Project	IEEE 802.16 Broadband Wireless Access Working Group http://ieee802.org/16 >		
Title	Clarifications for AAS Zone Allocations		
Date Submitted	2005-1-25		
Source(s)	Dave Pechner, Doug Dahlby, Todd Chauvin	ArrayComm Inc.	dpechner@arraycomm.com, dahlby@arraycomm.com, chauvin@arraycomm.com,
	Ran Yaviv, Tal Kaitz	Alvarion	Ran.yaniv@alvarion.com
	InSeok Hwang	Samsung	Is91.hwang@samsung.com
	Yuval Lomnitz, Hassan Yaghoobi	Intel	yuval.lomnitz@intel.com, hassan.yaghoobi@intel.com
Re:	IEEE P802.16-REVd/D5		
Abstract	This contribution introduces clarifications for making allocations in an AAS zone in the OFDMA PHY		
Purpose	Adopt into P802.16d/D5 corrigenda		
Notice	This document has been prepared to assist IEEE 802.16. It is offered as a basis for discussion and is not binding on the contributing individual(s) or organization(s). The material in this document is subject to change in form and content after further study. The contributor(s) reserve(s) the right to add, amend or withdraw material contained herein.

Clarifications for AAS Zone Allocations

Example 1 – UIUC 12 region is an integer number of slots

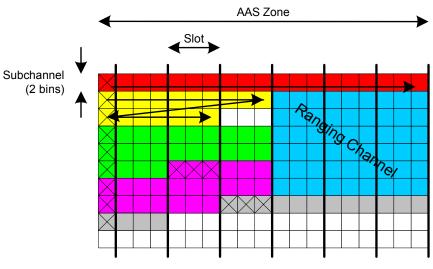
- 4) The first Uplink_preamble_config symbols of the UL AAS zone are reserved for UL AAS preambles. On a given subchannel, an UL AAS preamble will be inserted into these symbols by the SS devices who is allocated the slot following the preamble (or following a UIUC 12,13 region if it directly follows the preamble).
- 5) Any preamble inserted in an AAS zone in a location other than the first Uplink preamble config symbols shall be 3 symbols in duration.
- 6) Fast feedback channels must be allocated an integer number of slots. If a fast feedback channel wraps at the end of an AAS zone, the first Uplink_preamble_config symbols of the UL AAS zone are skipped to maintain slot alignment.

The following figures show valid UL AAS Zones.

Example 3 – UIUC 12 region spans all subchannels and duration is not an integer number of slots.

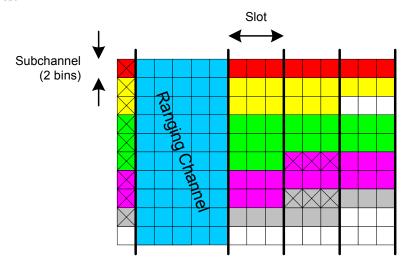
Example 2 – UIUC 12 region directly follows preambles

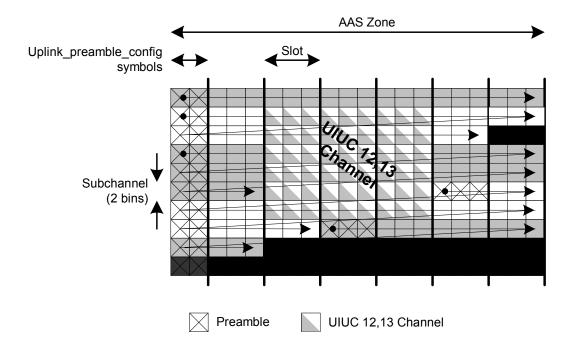
UL and DL allocations are made exclusive of the AAS preamble. In the DL, a 2D allocation burst is preceded by the appropriate DL AAS preamble. In the UL, a 1D allocation is preceded by the appropriate AAS preamble. The absolute slot offset for the UL AAS allocation indicates the first data slot, which is preceded by the appropriate AAS preamble. If an UL allocation wraps at the end of the AAS zone, the data allocation does not include the symbols required for the initial AAS zone preambles.

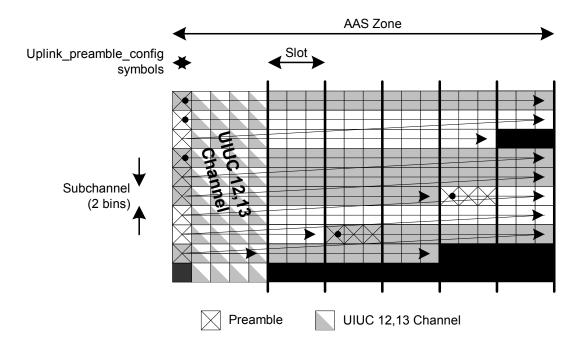
The figure below shows a legal UL AAS zone with an UIUC 12,13 allocation that is an integer number of slots in duration.
